Approved Section 4.55 (.....2.....) Modification Application

In respect to.....SSD 7484.....

SANDSTONE PRECINCT
23-39 BRIDGE STREET
SYDNEY, NSW, 2000

DEMOLITION ELEVATIONS LANDS BUILDING - SOUTH AND EDUCATION BUILDING - SOUTH

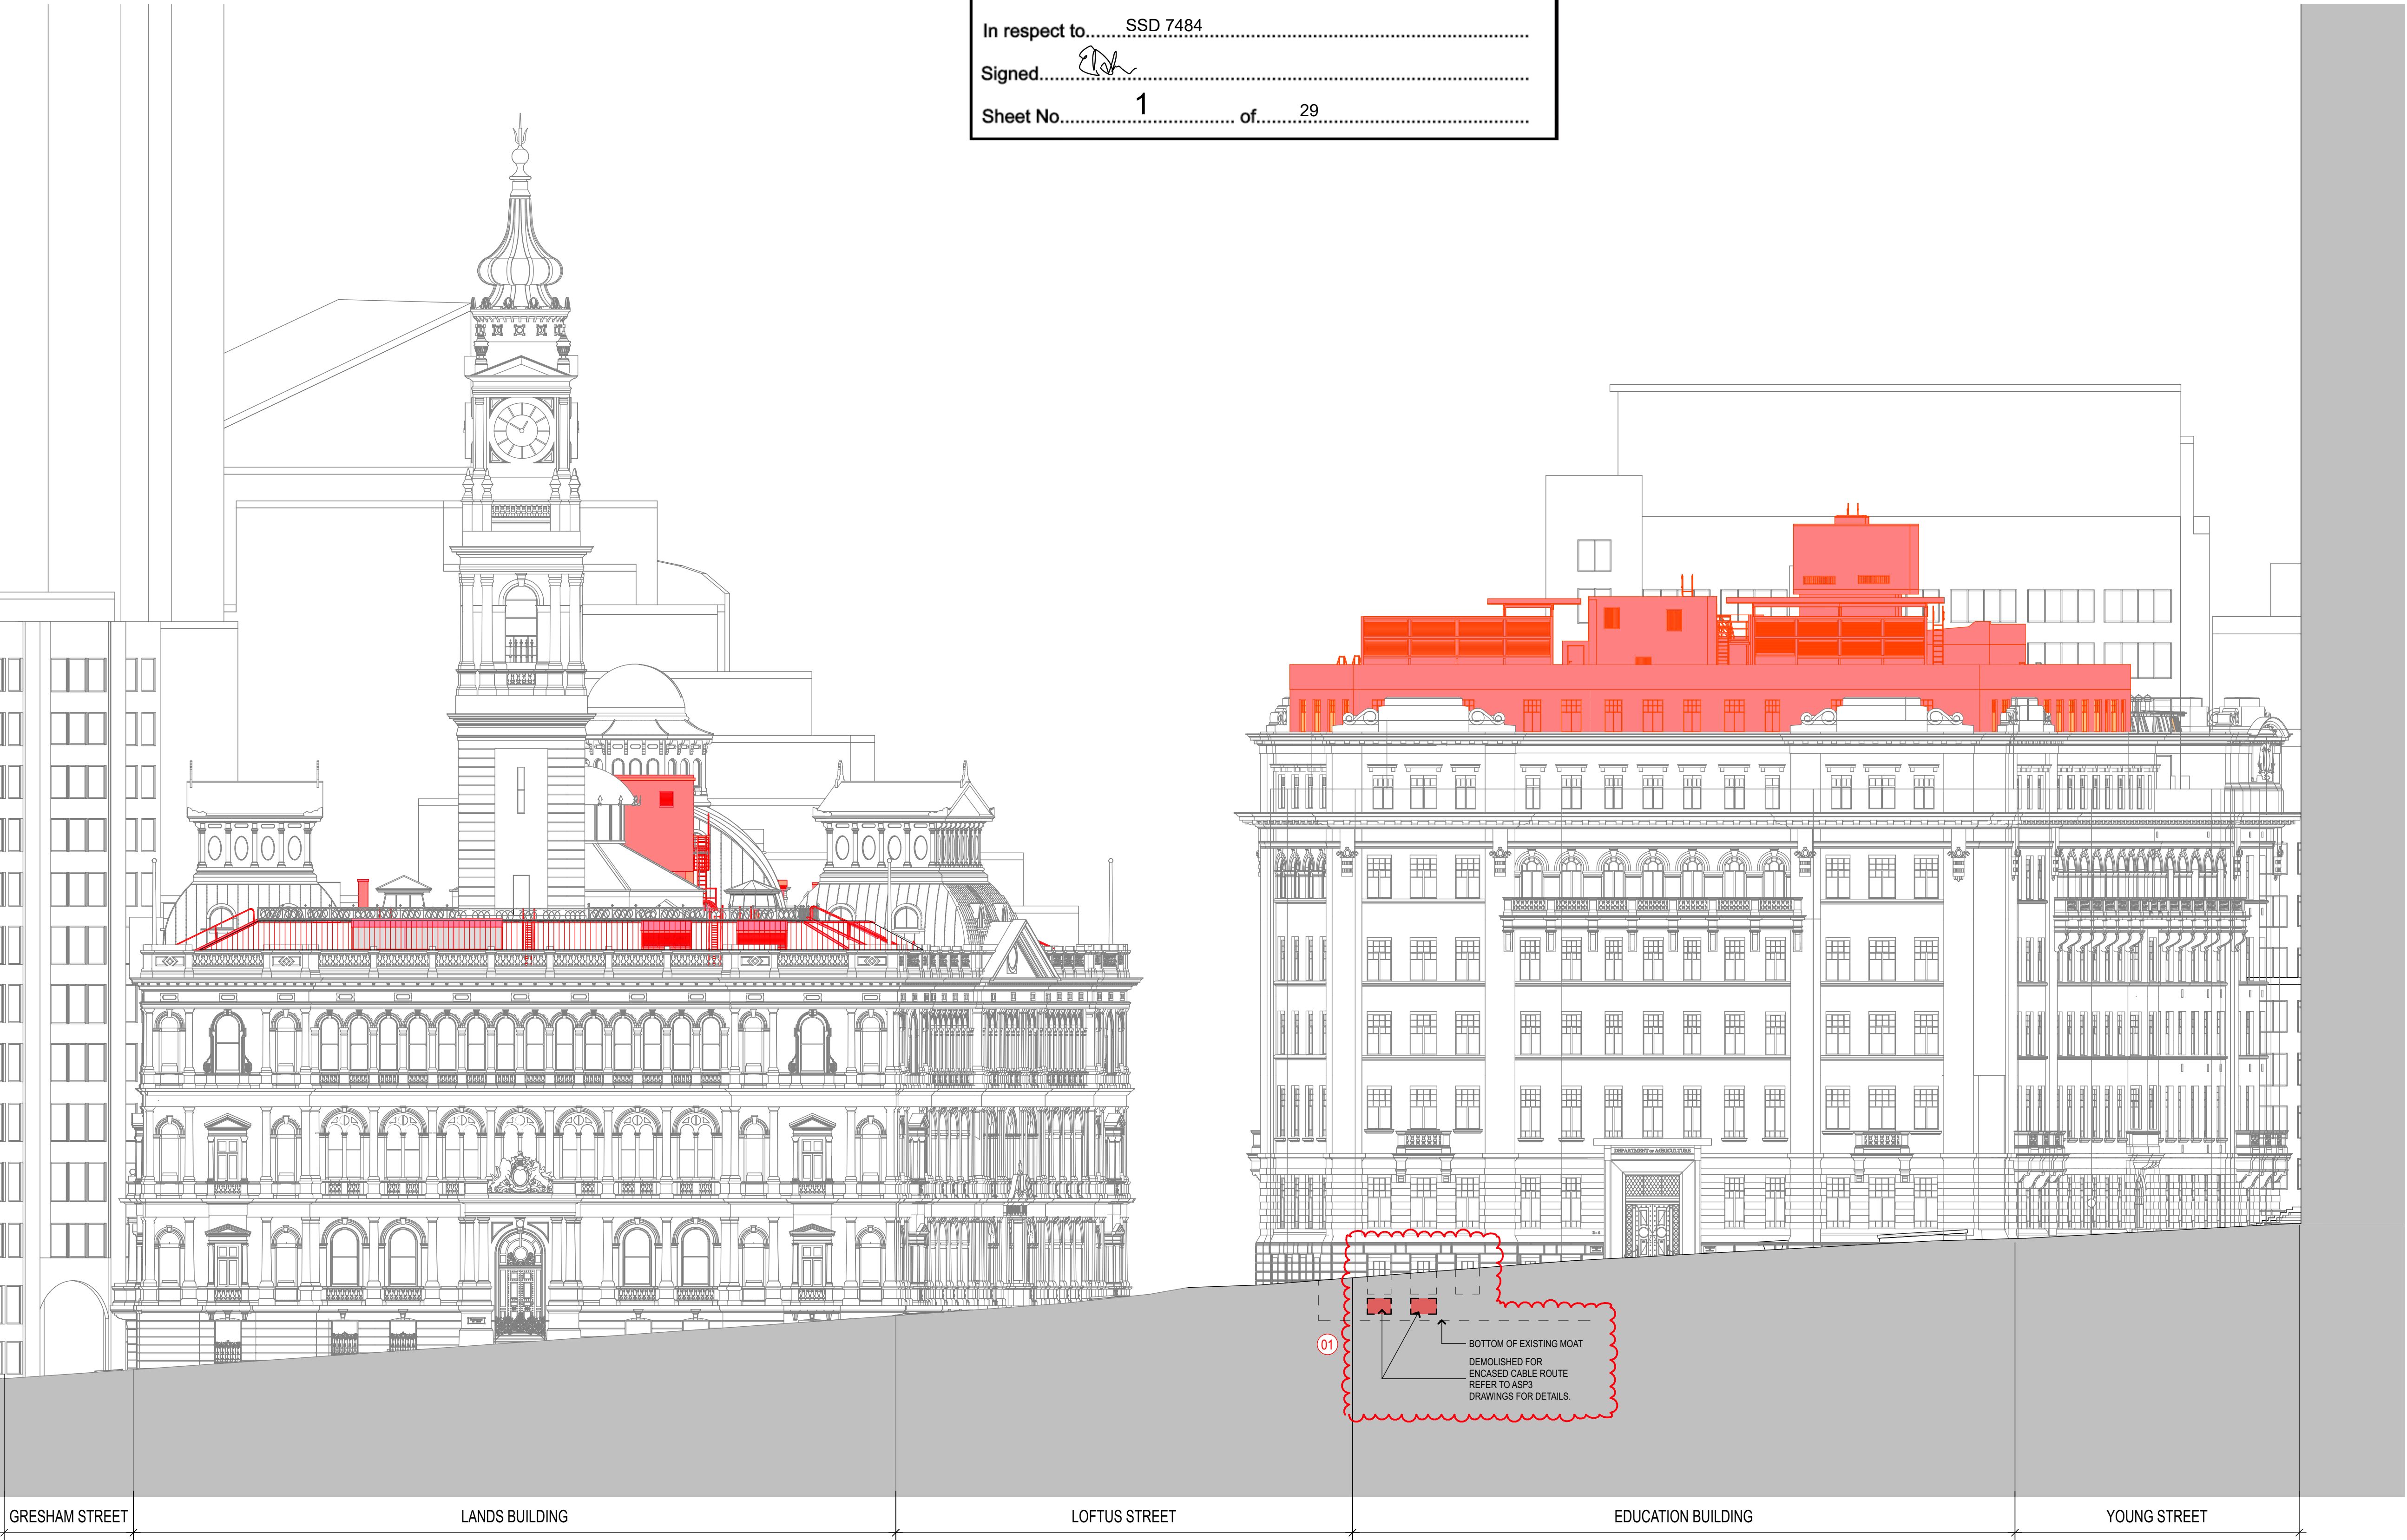
01	DEMOLISHED FOR ENCASED CABLE ROUTE
----	------------------------------------

01 EDUCATION BUILDING - DEMOLITION WEST ELEVATION

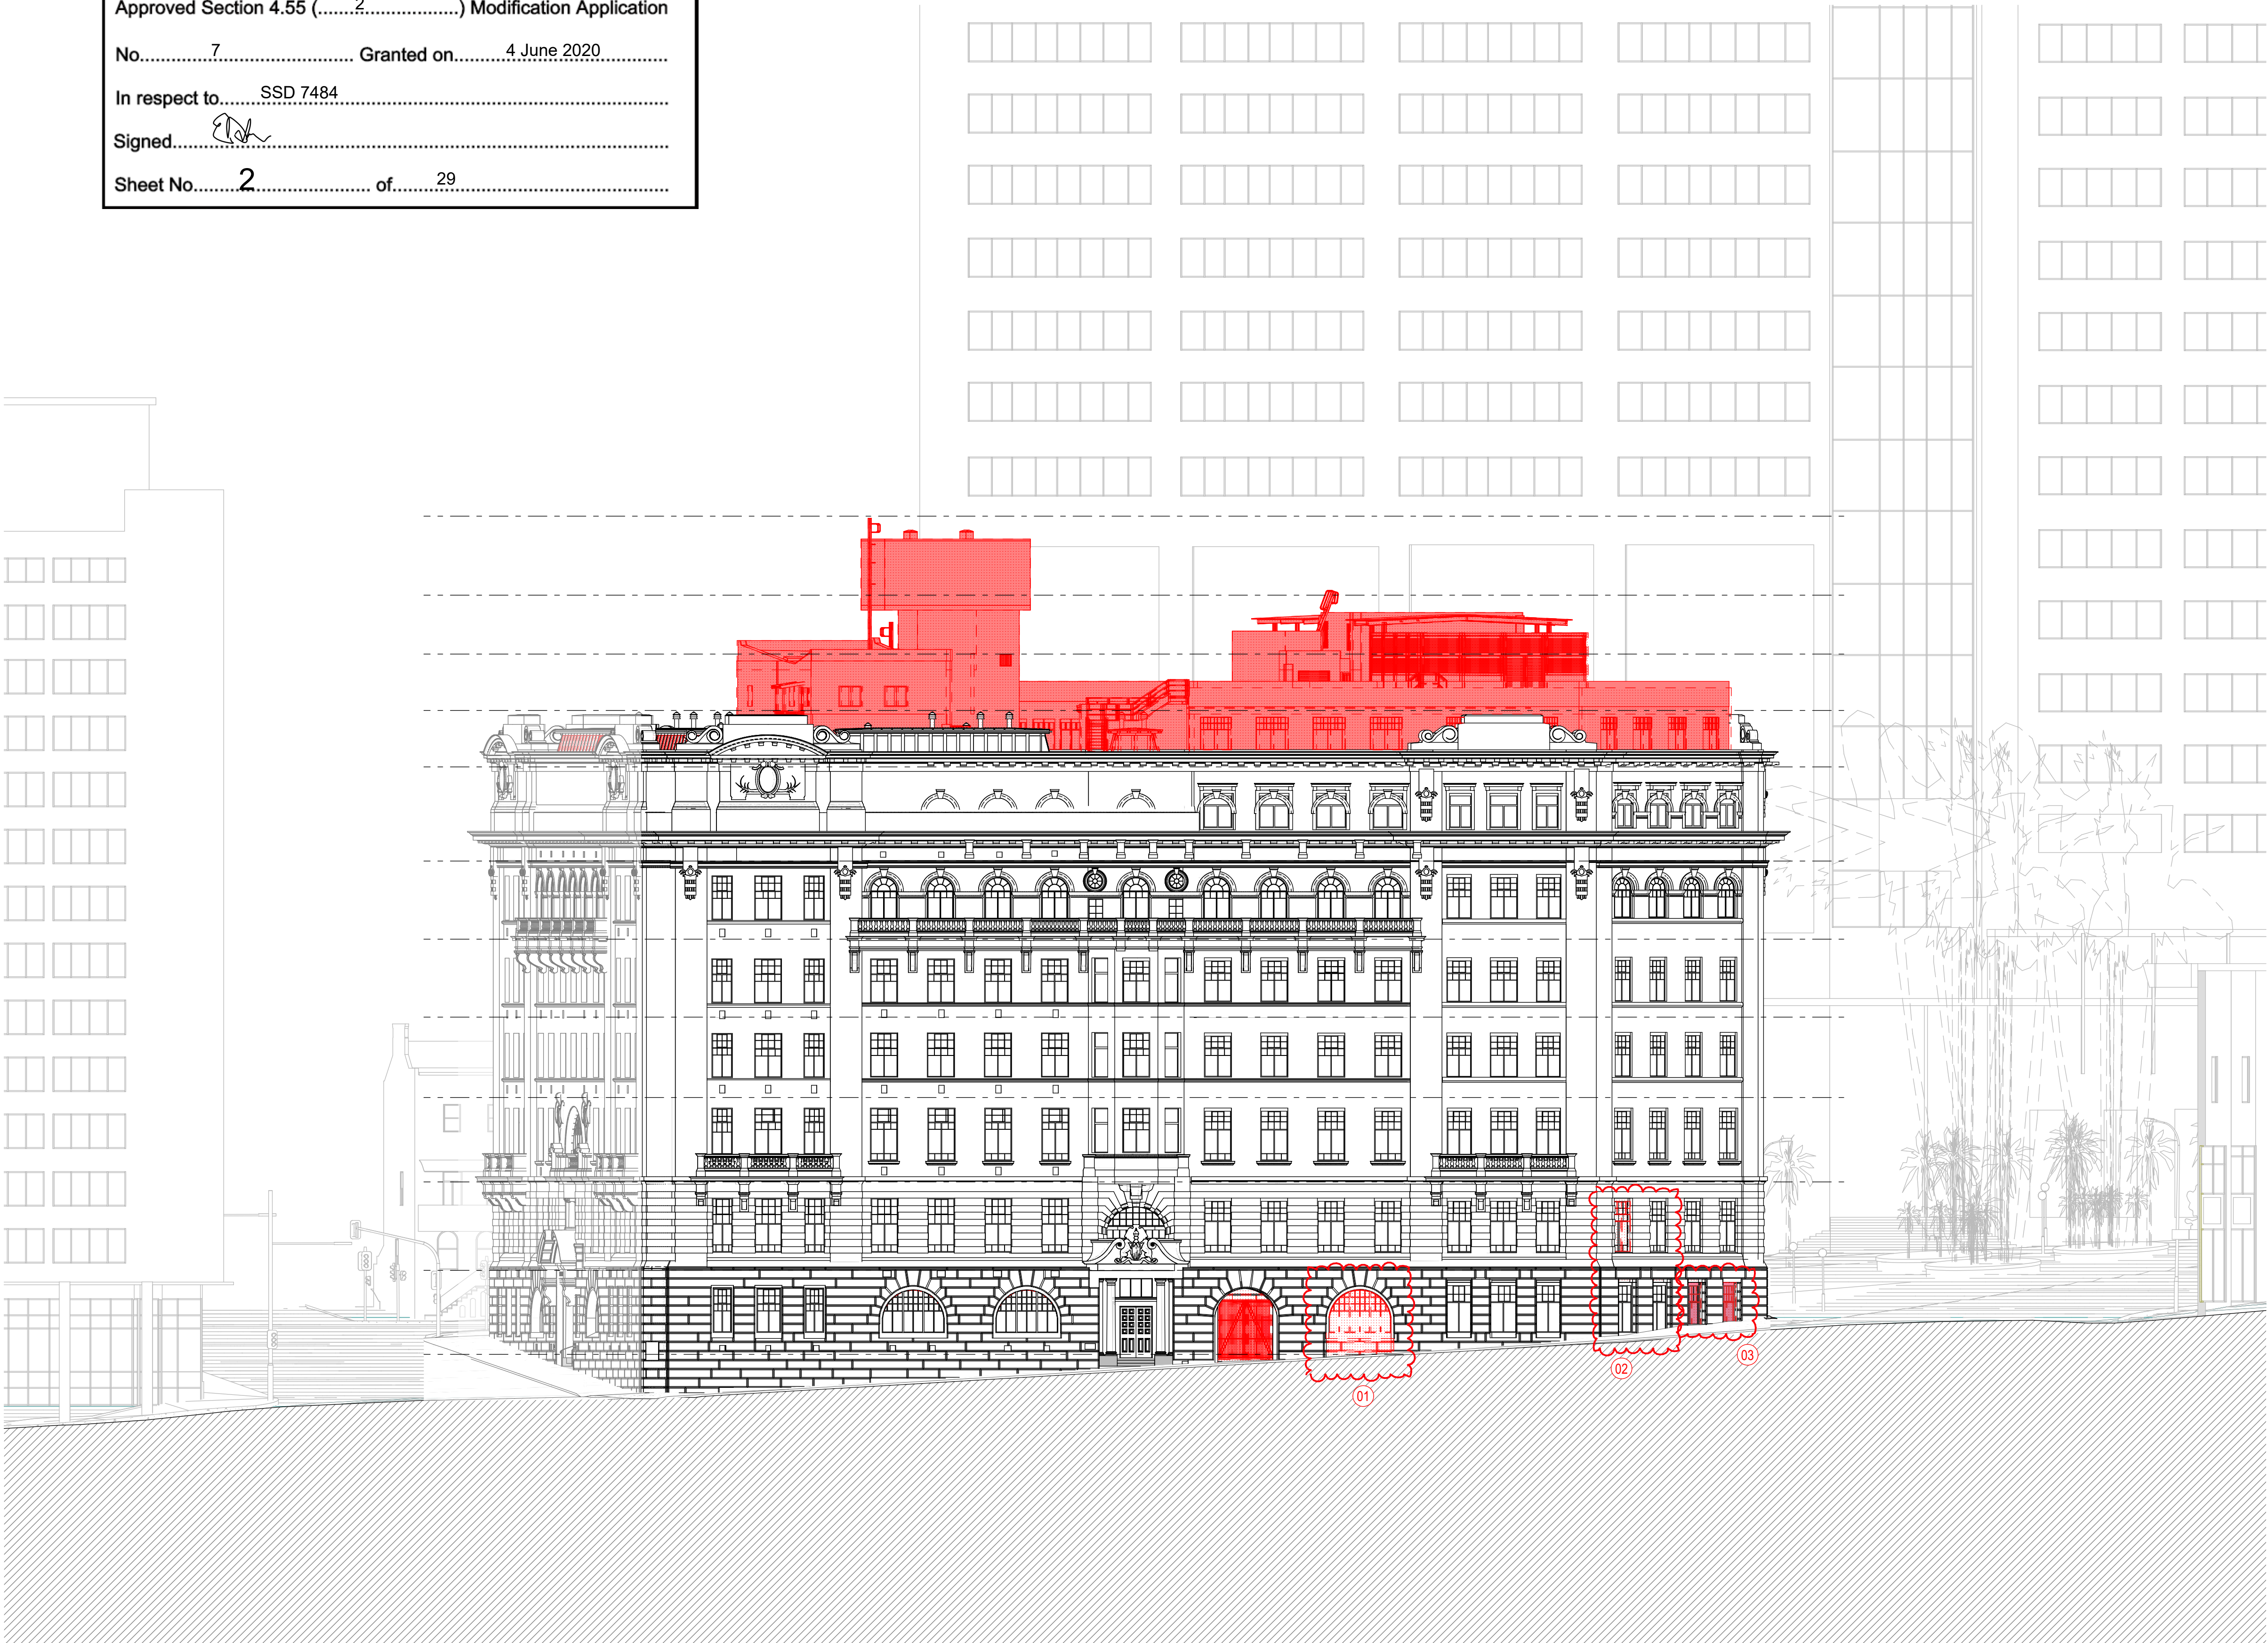
CHANGES LEGEND:	
01	DEMOLISH WINDOW AND WALL FOR NEW SUBSTATION EQUIPMENT DOORS
02	REMOVE EXISTING GLAZING AND RETAIN EXISTING WINDOW FRAME. REPLACE WITH NEW LOUVER FOR SUBSTATION INTAKE.
03	REMOVE WINDOWS FOR LUGGAGE ENTRY DOOR AND SUBSTATION EGRESS DOOR.

TITLE
**PROPOSED PLANS - EDUCATION BUILDING
- BASEMENT 03**

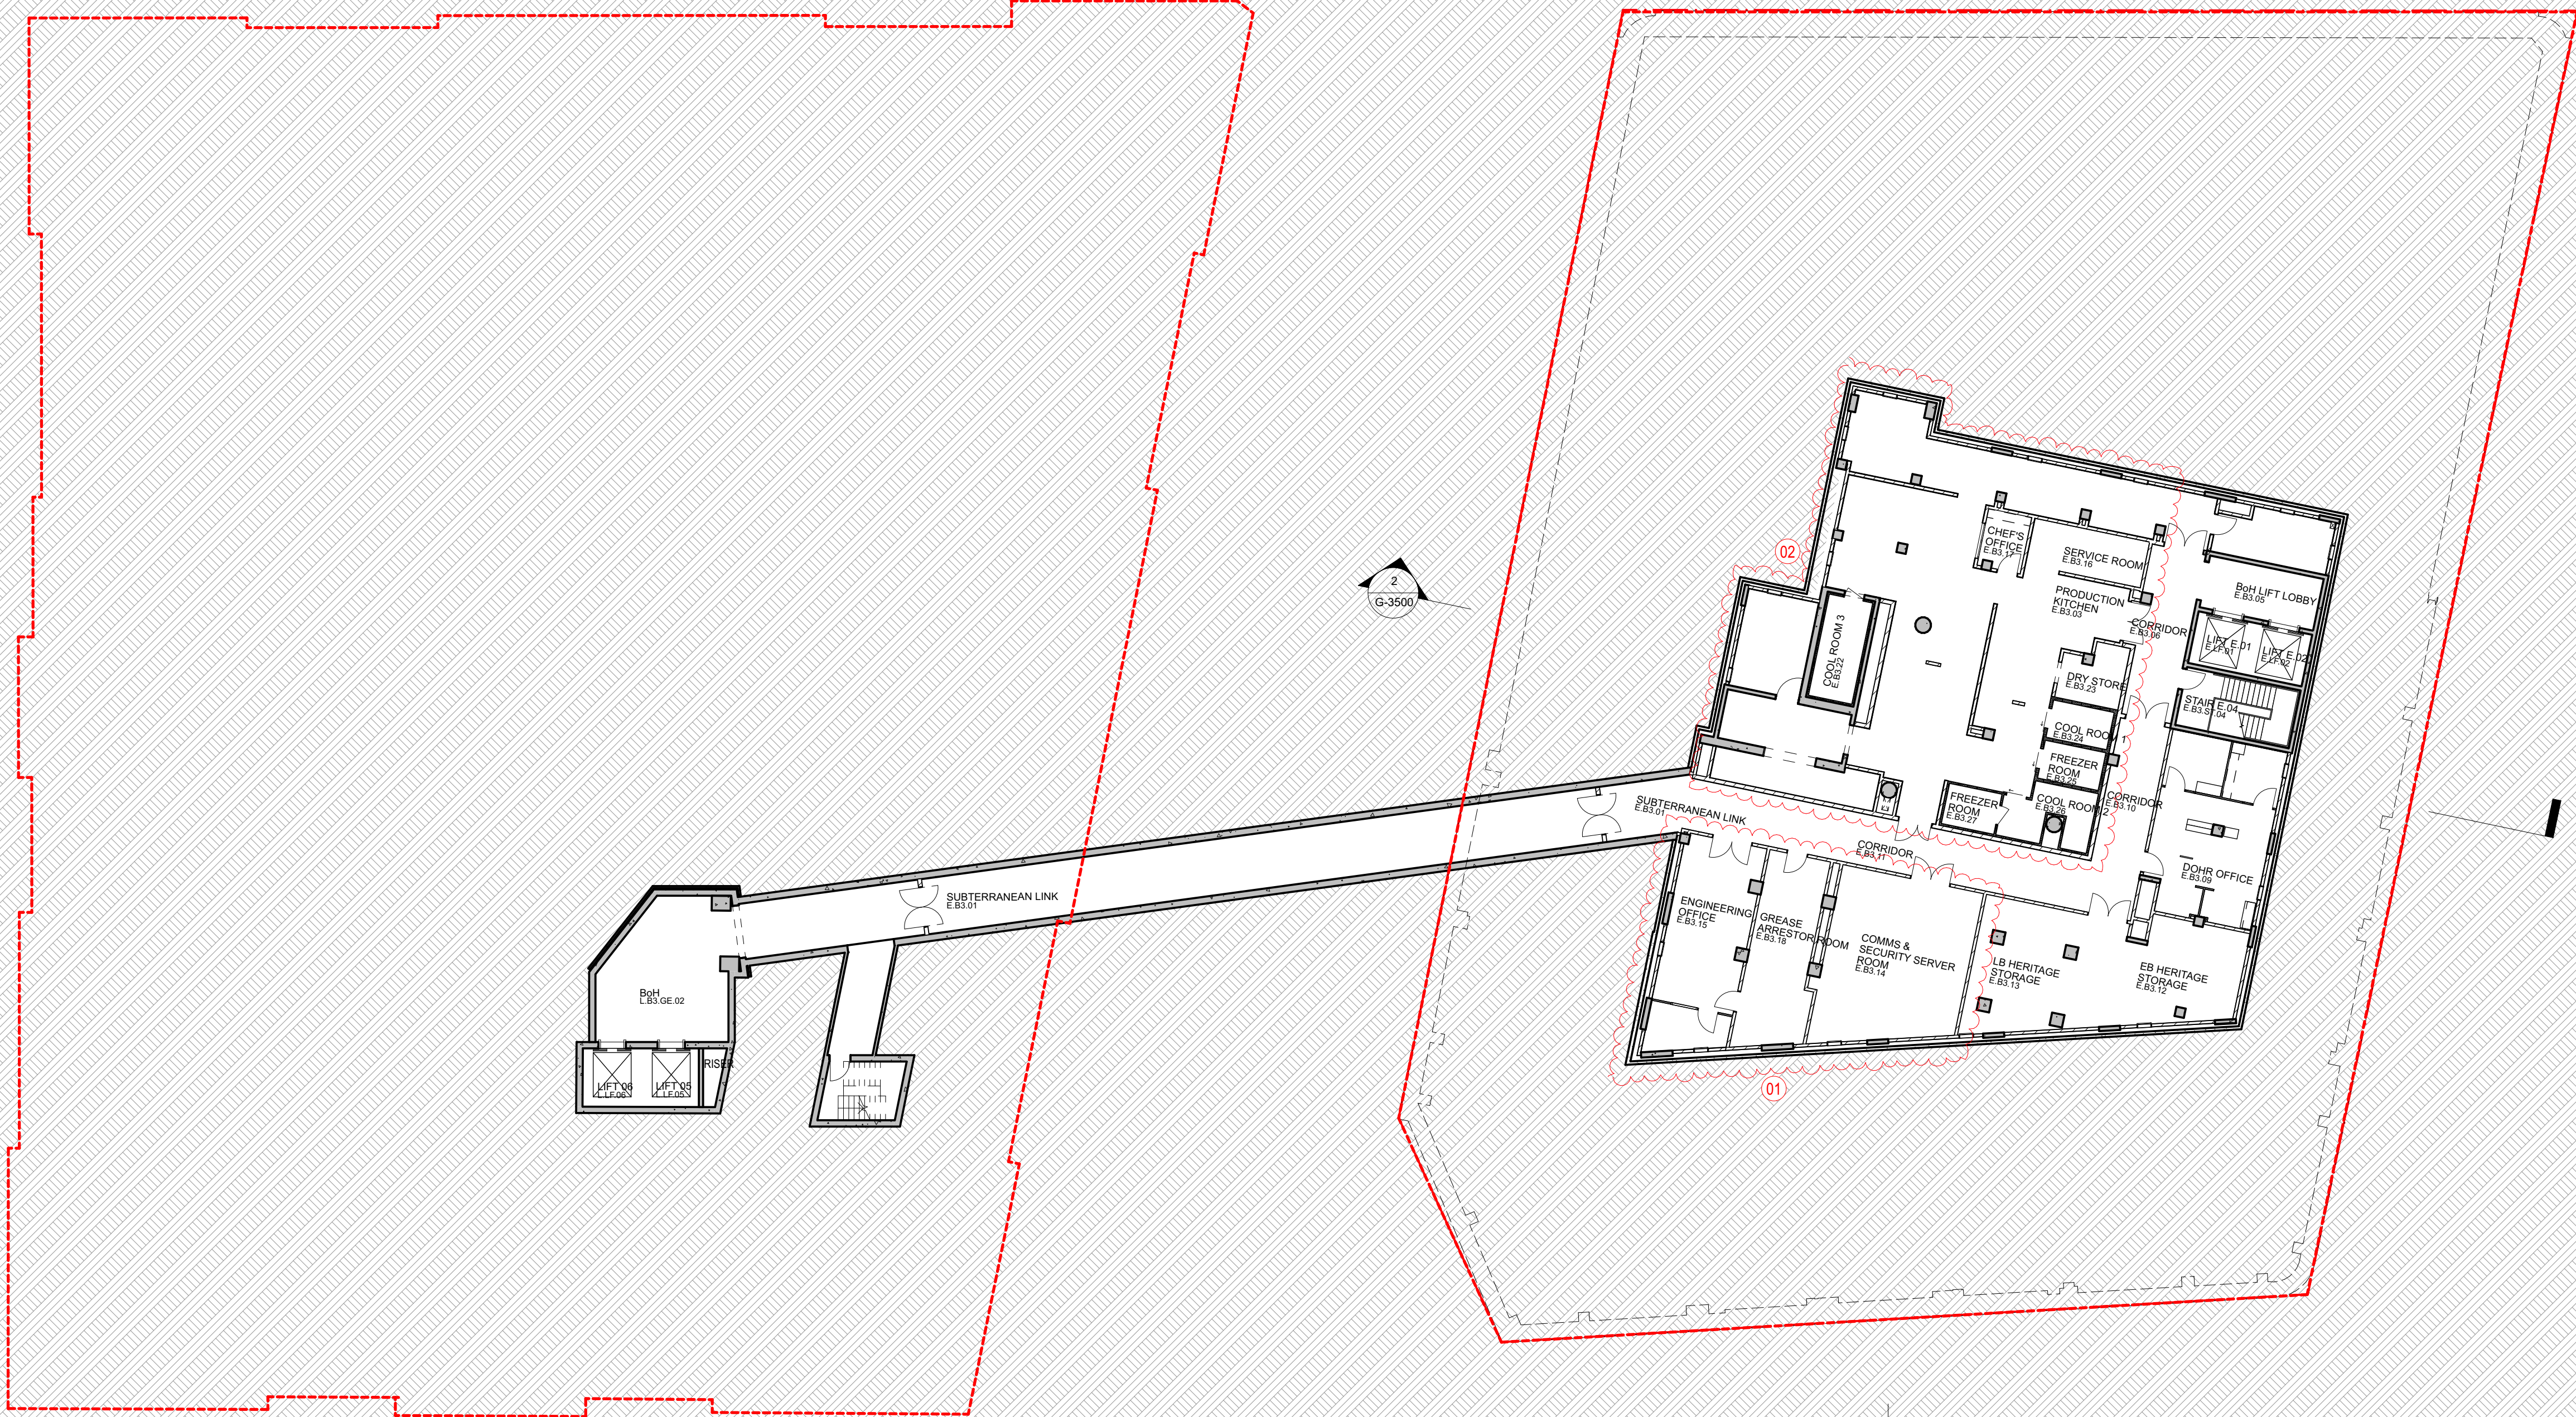
- CHANGES LEGEND:
- 01 SOUTH WEST ROOMS LAYOUT UPDATED
GREASE ARRESTOR ROOM RELOCATED
 - 02 PRODUCTION KITCHEN LAYOUT REVISED
